## ***Interactive comment on “Using globally available soil moisture indicators for flood modelling in Mediterranean catchments” by C. Massari et al.***

Replies to the comments of the Anonymous Referee #2

(please see the attachments or the PDF supplment) Figure 1(a) Figure 1(b) Figure 1: Observed (Qobs) and simulated (QSM\_obs, QSM\_ASCAT) discharges obtained in validation for the event of 21 Febraury 2013 using soil moisture from in situ data (a) and from the advance scatterometer ASCAT (b).

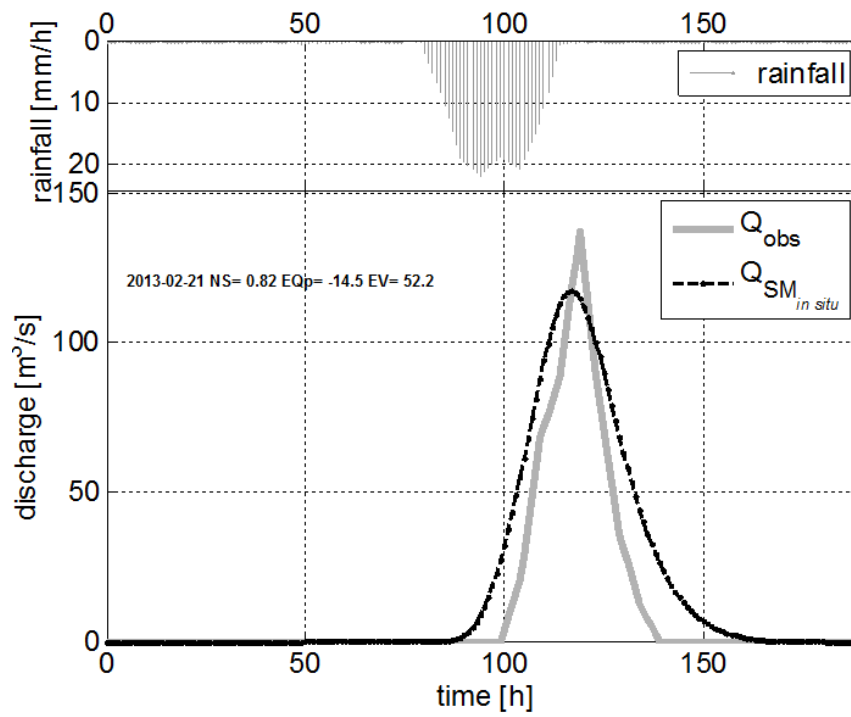
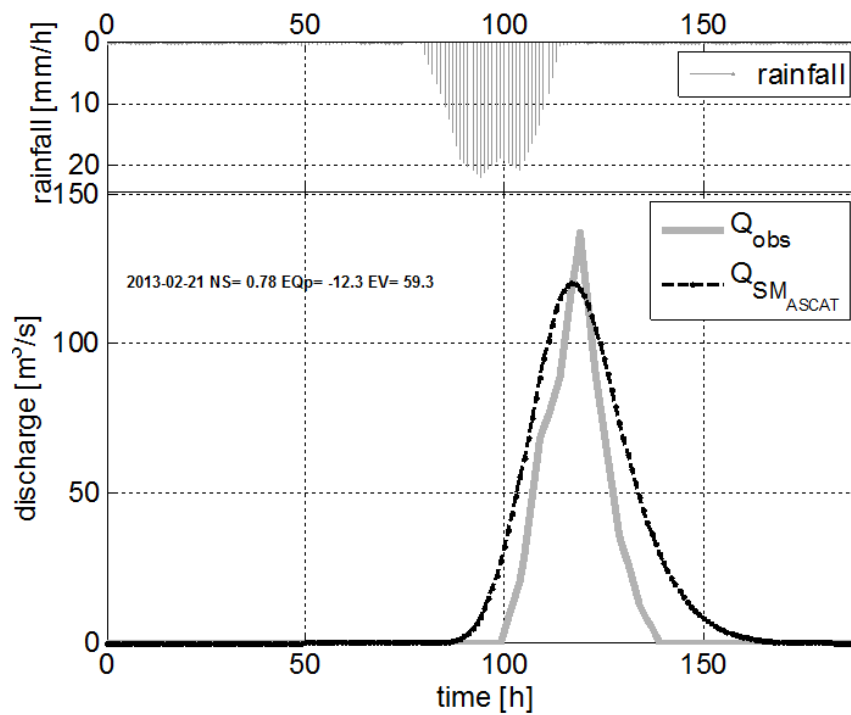
1. The overall purpose of the paper is to provide soil moisture estimates at the start of flood events for flood prediction and flood risk management. However, the data used in the manuscript concerns low-to-moderate rainfall-runoff events. For the selected events, the max peak discharge is around 40 m<sup>3</sup>/s, i.e. 0.4 m<sup>3</sup>/(s km<sup>2</sup>), with 8 events less or equal than 6.7 m<sup>3</sup>/s. These magnitudes should be contrasted with the intensities of flood events of some relevance for risk management in the region (as a reference, the 500-yr return period peak discharge is estimated around 250 m<sup>3</sup>/s (Karagiorgos et al., 2012 and references therein)). The gap between the 'real' flood conditions in the basin and the analyzed rainfall-runoff events is totally understandable: the period considered in the study (from March 2009 to December 2012), was probably too short to capture significant flood events. Nevertheless, the gap should be identified by the authors, and the implications should be discussed. On the one hand, I think that the value of the technical analysis is not affected by the use of low-magnitude events, since the impact of the initial soil moisture conditions is (generally) expected to

be more important for low magnitude events and to decrease with the magnitude of the event (however, Marchi et al., 2010, identified that the impact of initial wetness condition is still important for extreme flash flood events). On the other hand, it should be borne in mind that some assumptions used in the modelling chain may be less realistic when low-magnitude events are considered. This is the case of the lumped approach and the rainfall estimation procedure: small scale events are usually more affected by rainfall spatial variability than extreme events are. As a further and necessary step, the authors should identify how the findings from this analysis can be extrapolated to more severe events.

Reply: The need to show the performance of different kind of soil moisture indicators at the time of the preparation of the paper forced us to restrict the analysis to a period in which all of them were available, e.g. AMSRE is not more available after October 2012. At the same time, we struggled to extend our analysis period in order to capture as many flood events as possible (especially the bigger ones). Hence, we decided to not include events after December 2012, such as for instance, a large event (the largest among the ones considered) occurred on 21 February 2013. To show that our approach is robust and works well also for high magnitude floods we will include here and in the revised version of the paper (as independent event) the results obtained in validation for such an event which has recorded a total peak discharge of about 150 m<sup>3</sup>/s (i.e. about three times the the maximum recorded in the previous analysis). To run the model we used the parameters obtained by the calibration against the first eight events as described in Section 4.3.2 of the paper. As indicator of soil moisture prior to the flood events we used soil moisture data from the Advanced Scatterometer (ASCAT, pixel 1999295) and in situ soil moisture recorded at Pikermi station. Due to the lack of rainfall data in this period for Kantza and Spata stations, only 4 rain gauges were used for the analysis (Pikermi, Penteli, R400 and R600, please refer to Figure 2 of the paper to visualize them). Figure 1a and b show the simulated and the observed discharge obtained for the event of 21 February 2013 using in situ and ASCAT soil moisture indicators, respectively (ERA-LAND indicator results' will be provided in the

revised version of the paper since we need to retrieve data for this period). As it can be seen results are very good giving NS equal to about 0.8 an error in peak discharge below 15% for both the indicators. This is relevant considering that the calibration was carried out on low-to-moderate flood events. Considering discharge estimations from previous studies it has to bear in mind that data for the catchment are relatively recent (we did not find any observations longer than 8 years) and a statistical analysis to extrapolate the value of the peak discharge for high return periods (such as the one carried out in Karagiorgos et al., 2012) must be handle with care. Concerning the effect of the spatial variability of the precipitation on low to moderate rainfall-runoff events, we know that this may affect the result of the analysis. In our study we have presented the worst possible situation (mean areal rainfall calculated by the Thiessen polygon method) obtaining to our point of view satisfactory results. Nonetheless, the model is very well suited to be extended to different mean area rainfall calculations and also to be modified to take into account the spatial variability of the precipitations in a semi-distributed manner like the MISDc model presented by Brocca et al. 2011.
